EEG-23

EVALUATION OF THE SUITABILITY OF THE WIPP SITE

Environmental Evaluation Group  
Environmental Improvement Division  
Health and Environment Department  
State of New Mexico

May 1983

Figure 17a. Geophysical logs of borehole AEC-8 and intervals that EEG contends should have been tested (logs adapted from SAND79-0269, 1983)

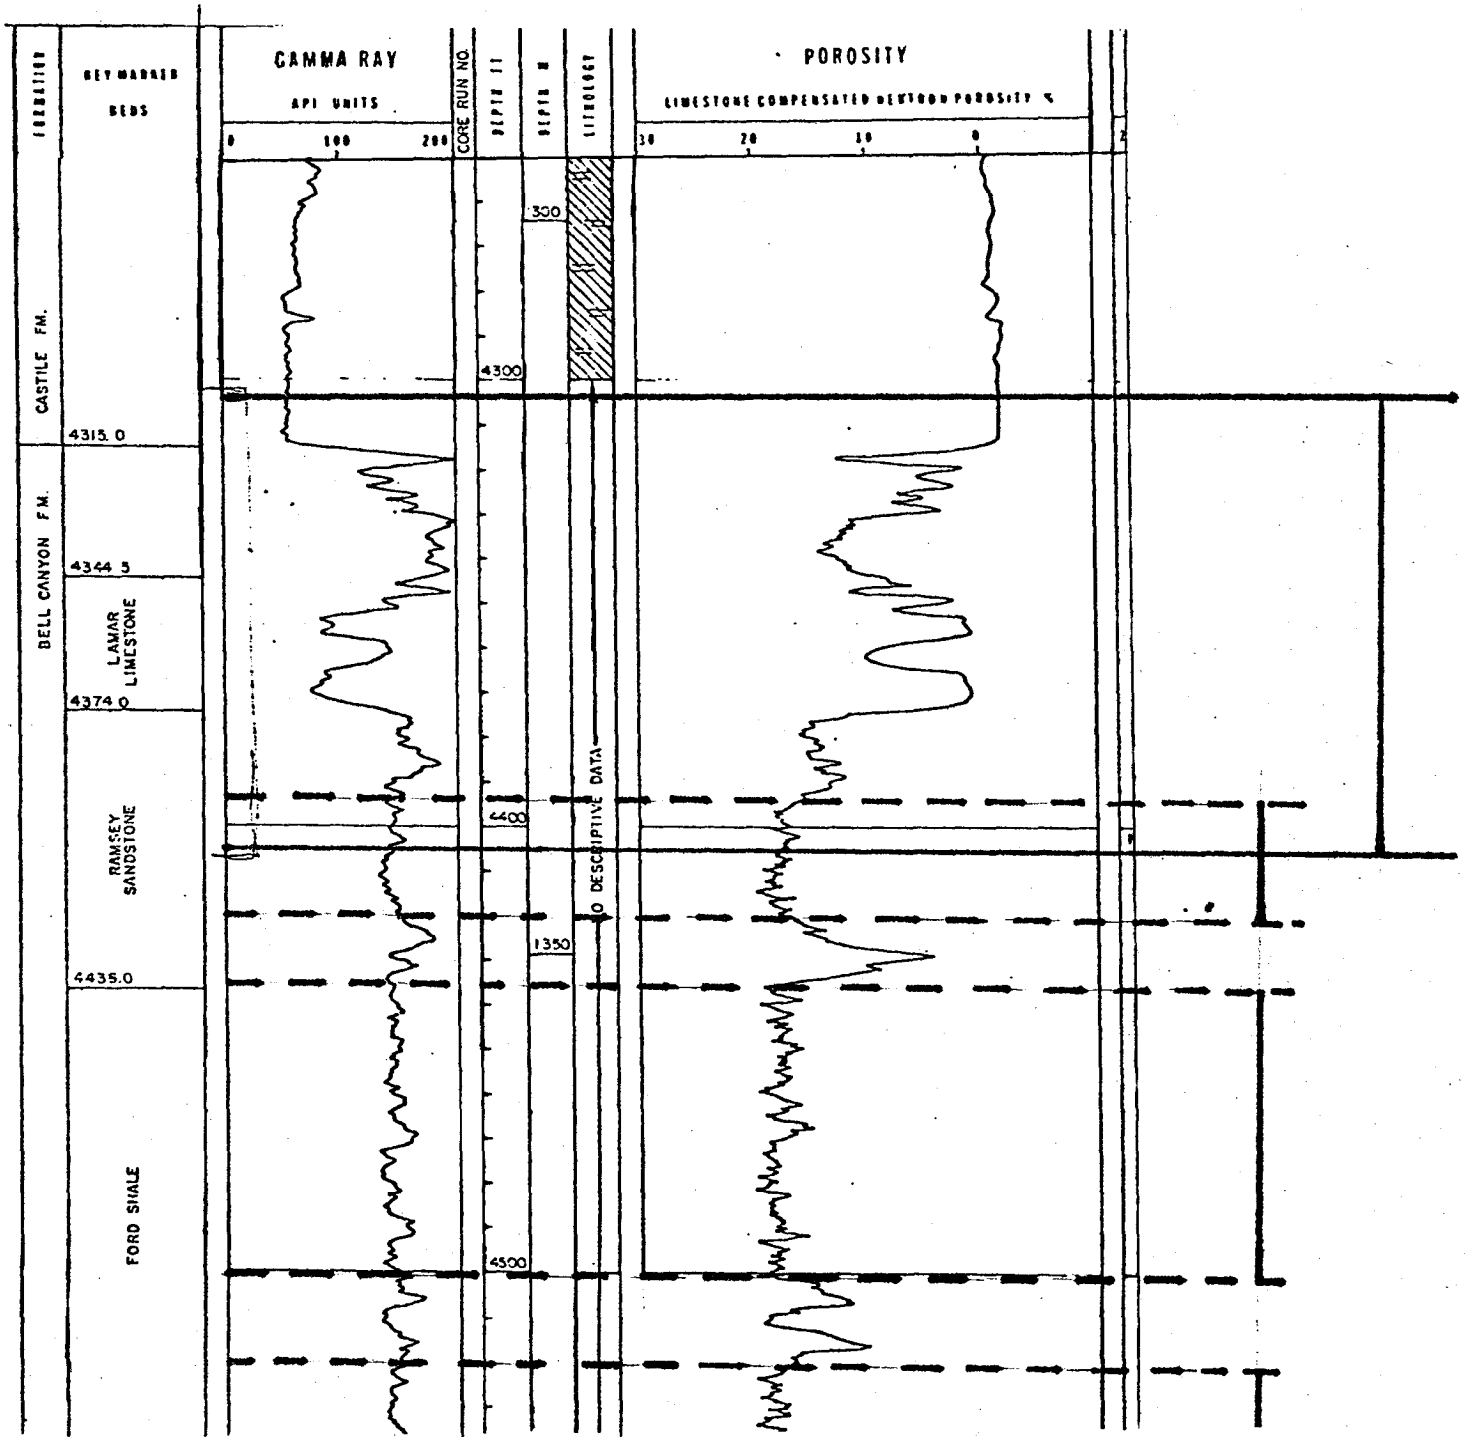
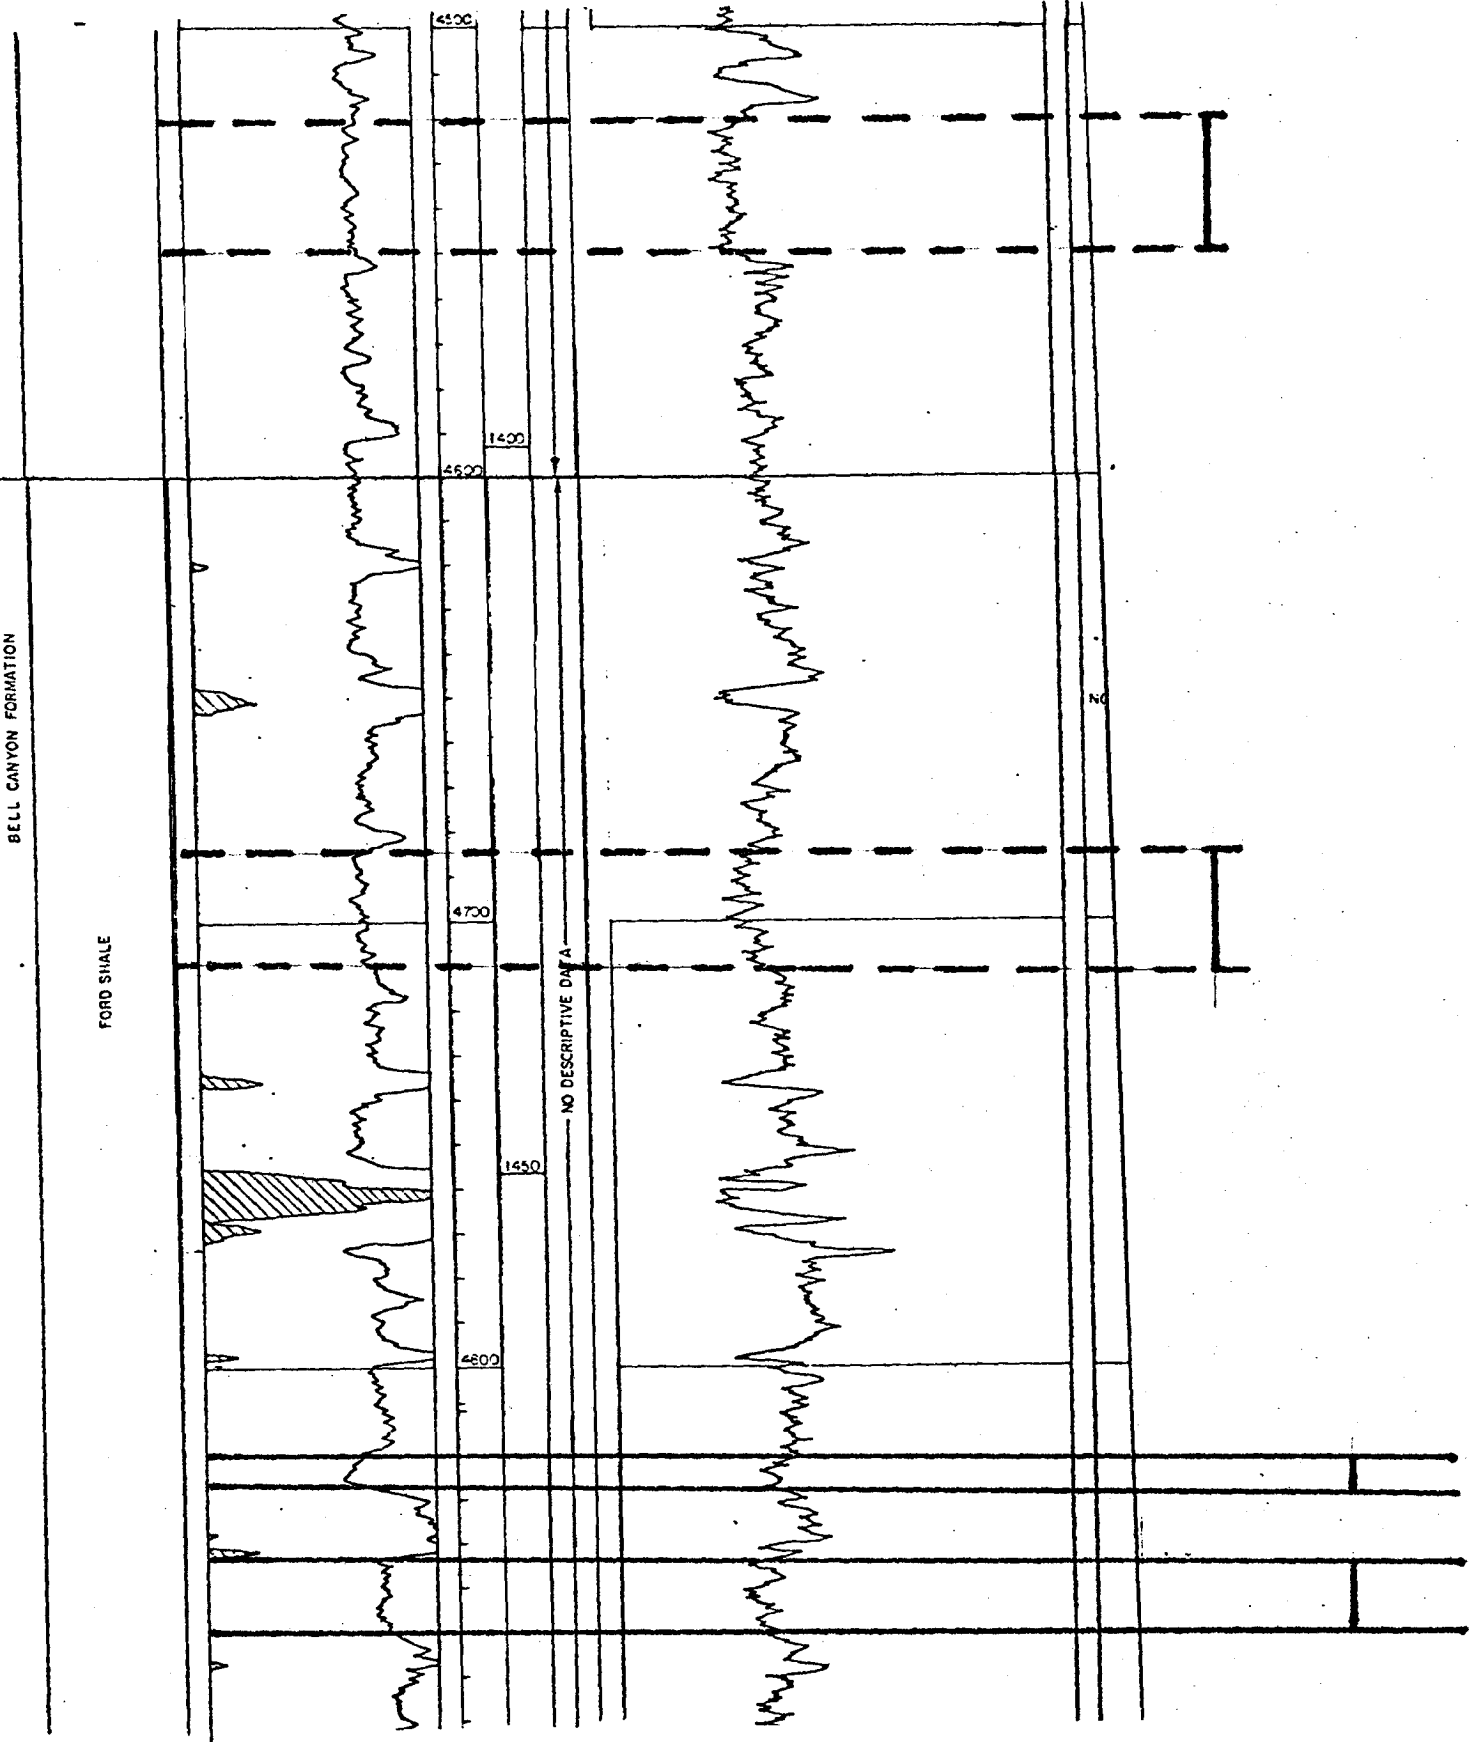
- The intervals tested in test hole AEC-8 appear to completely bypass the Ramsey sandstone member. Geophysical logs of the upper Bell Canyon including the 2 tested intervals are presented in Figure 17. The two sand units were chosen for testing because "The natural gamma log indicated that the two units were predominantly sandstone and the porosity log indicated that they

had greater porosities than other Bell Canyon sand units." (Mercer and Orr, 1979, p. 127). Four other sand units, not tested, which possess very similar geophysical log signatures as the intervals tested are indicated on Figure 17. These other untested sand units with a combined thickness of 150 feet, are stratigraphically closer to the repository and would have been logical intervals to test.

Figure 18. Adjusted potentiometric surface of the Culebra Dolomite Member of the Rustler Formation (1982) at and near the proposed WIPP site (from Mercer, 1983)

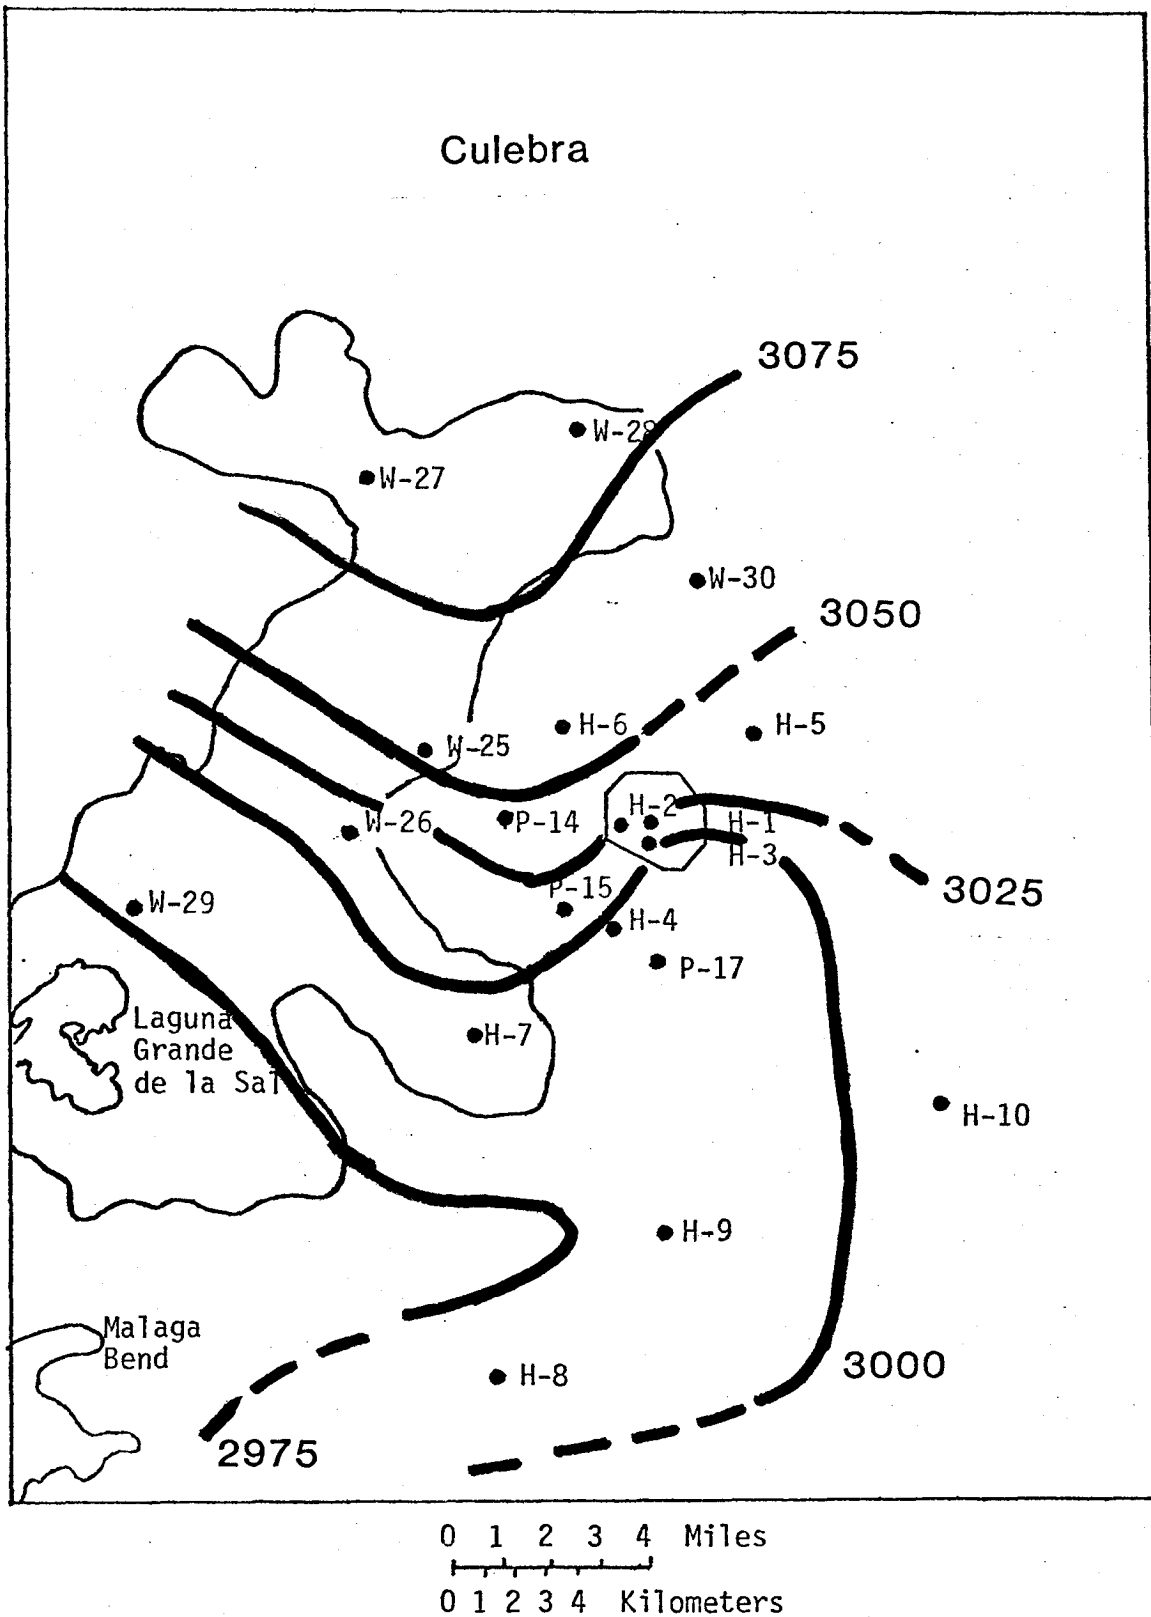
The potentiometric surface map of the Culebra is presented in Figure 18. From these data one might conclude that the direction of flow from the site is due south to about the center of T 23S, R. 31E, and then southwest to a discharge point at Malaga Bend. Recent work by Gonzalez (1983) to define the anisotropy of hydraulic conductivity (Figure 25) has led to the conclusion by DOE that the flow from the site will be southeast and then westerly to Malaga Bend. The decrease in TDS and the change in water chemistry from sodium and chloride to calcium, magnesium and sulfate south of the site has been discussed in the Regional Hydrology section. Until the chemical inconsistencies are explained, the hydraulic head distribution shown in Figure 18 does not definitively show that the direction of groundwater flow is other than along a straight line to Malaga Bend. To date, the anisotropy of conductivity has been determined at only three locations; H-4, H-5, and H-6. The direction of the principal component of the transmissivity tensor is nearly identical at test pads H-5 and H-6. At H-4, the direction of the principal component of the transmissivity tensor is rotated about 50° counterclockwise in relation to H-5 and H-6. No data on anisotropy are available at the center of the site or to the southeast. Additional anisotropy tests are needed to accurately predict the direction of groundwater flow in the fractured Culebra Dolomite.

Figure 23. WIPP Site and the southern limits of the "Highly Disturbed Area" (GCR), the "Zone of Anomalous Seismic Reflection Data" and the "Steepening of Dip of Castile Strata" (SAR).

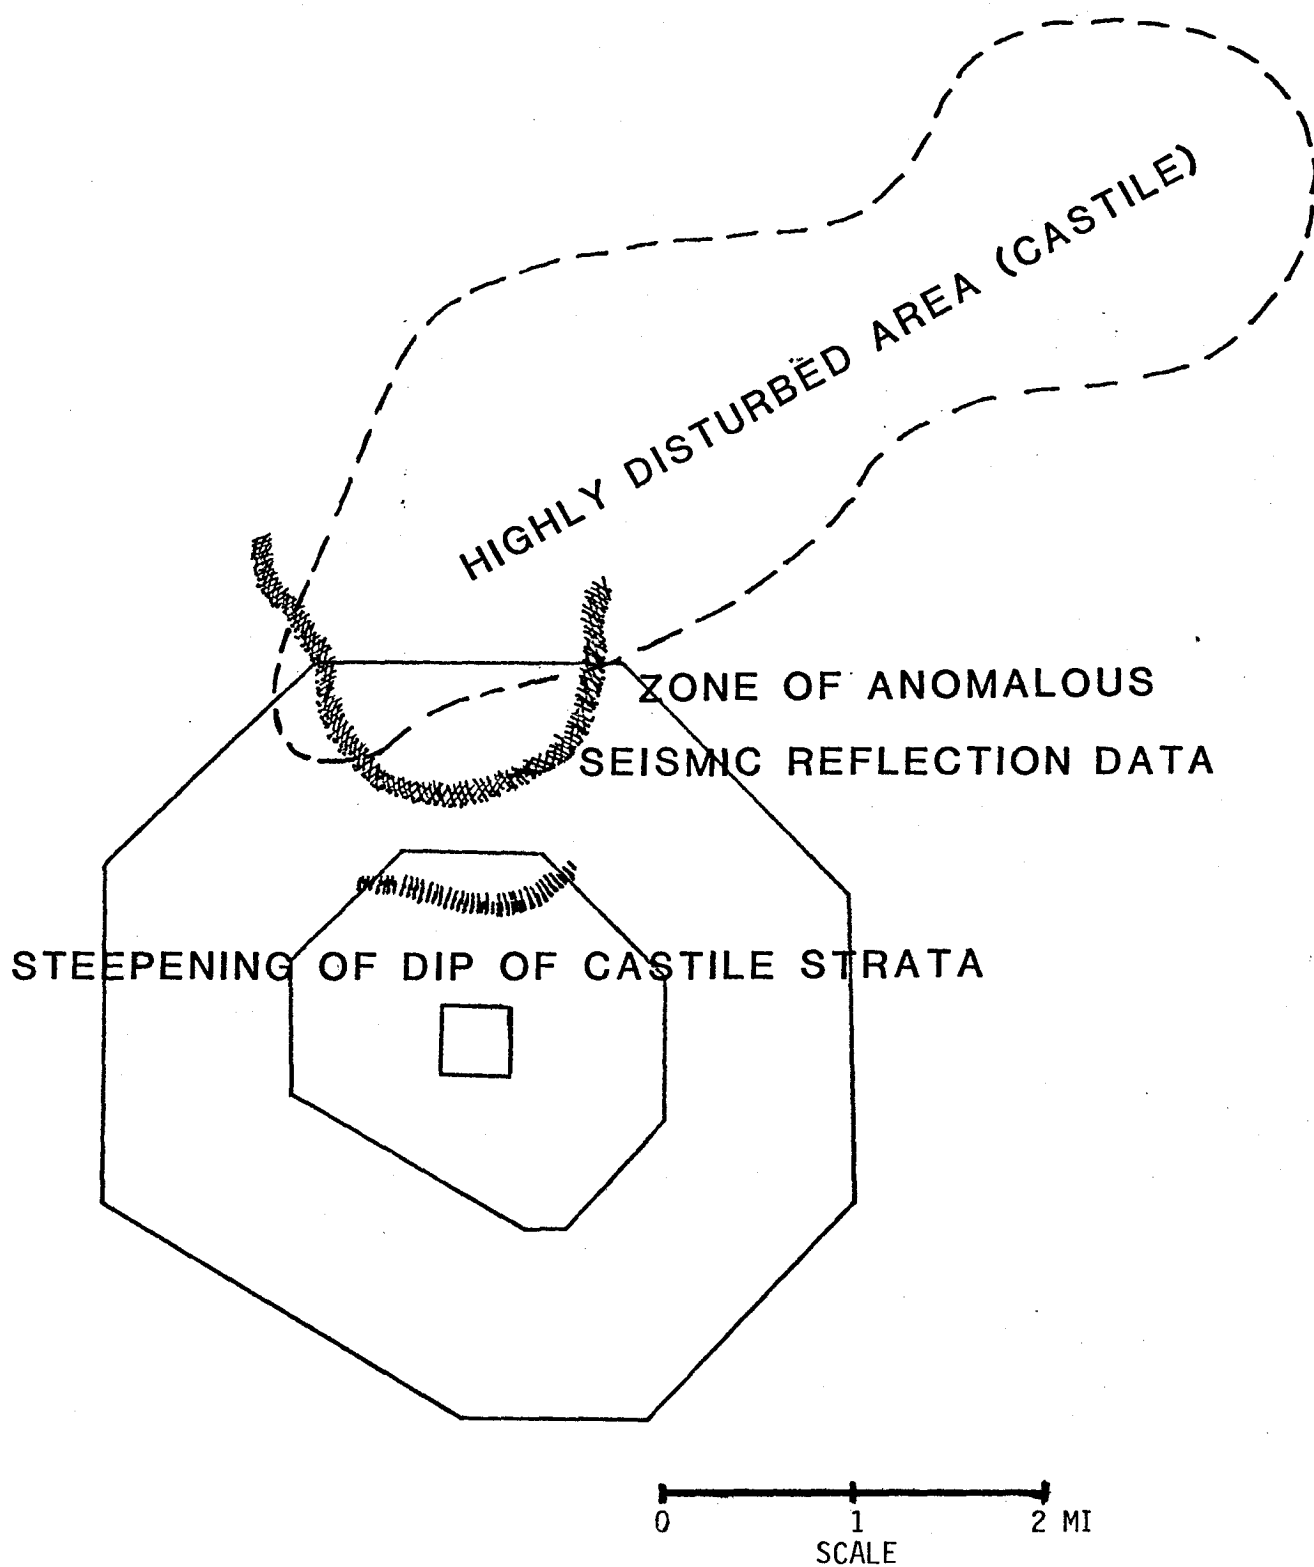
In earlier DOE publications, e.g. Powers et al (1978) and Register (1981)\*, the disturbed zone was presented as a zone bordering the Capitan Reef. Borns et al (1983) have widened this zone to include the WIPP-12 structure where brine was encountered. In addition, they have shown two more areas, to the southwest and south of the WIPP site (Fig. 23), as part of DZ. No rational explanation has been provided for separating these two areas from the band bordering the reef. The seismic profiles do show structures between WIPP-12 and Belco-Hudson well, but there are no wells penetrating the Castile formation between these two and, therefore, the boundary of the circular DZ shown southwest of the site in Figure 23 is arbitrary.

Figure 38. Stabilized piezometer readings and design pressure envelope of liner for exploratory shaft. (ref. 2).

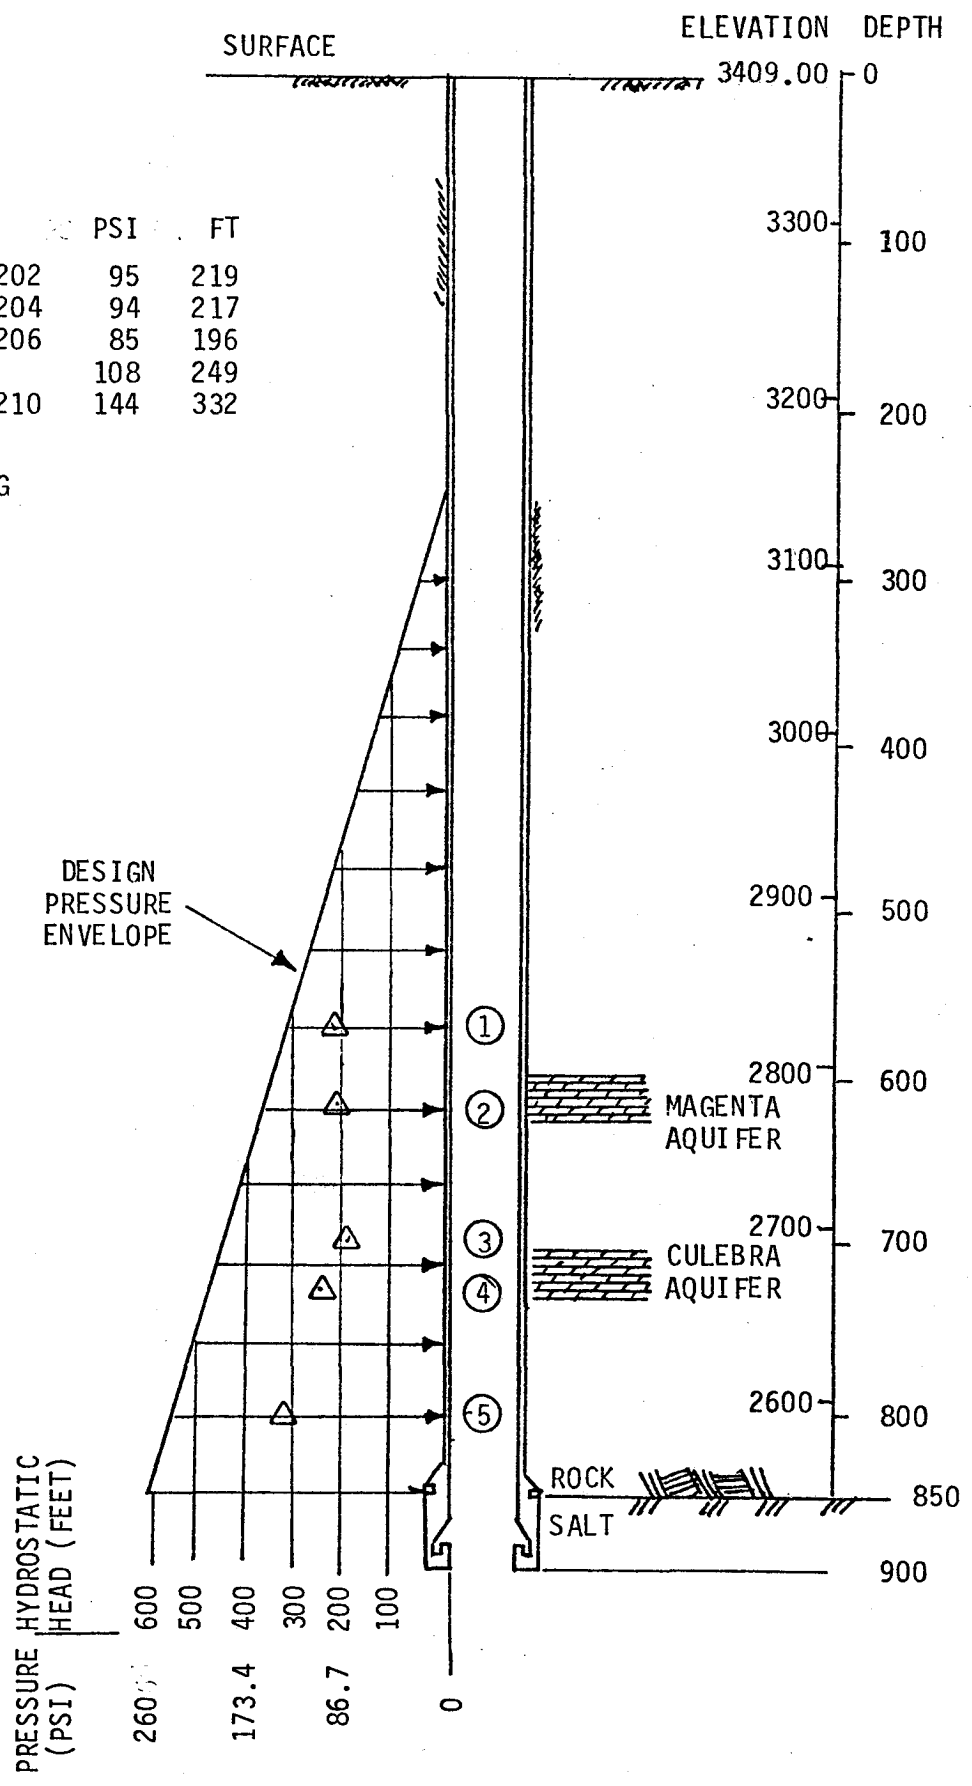
Figure 38 shows the stabilized readings from the piezometers installed behind the steel lining in the exploratory shaft. Also shown is the design hydrostatic pressure. There is no correlation of pressure with depth; hence, more data will be necessary before drawing any conclusions on these pressure readings.
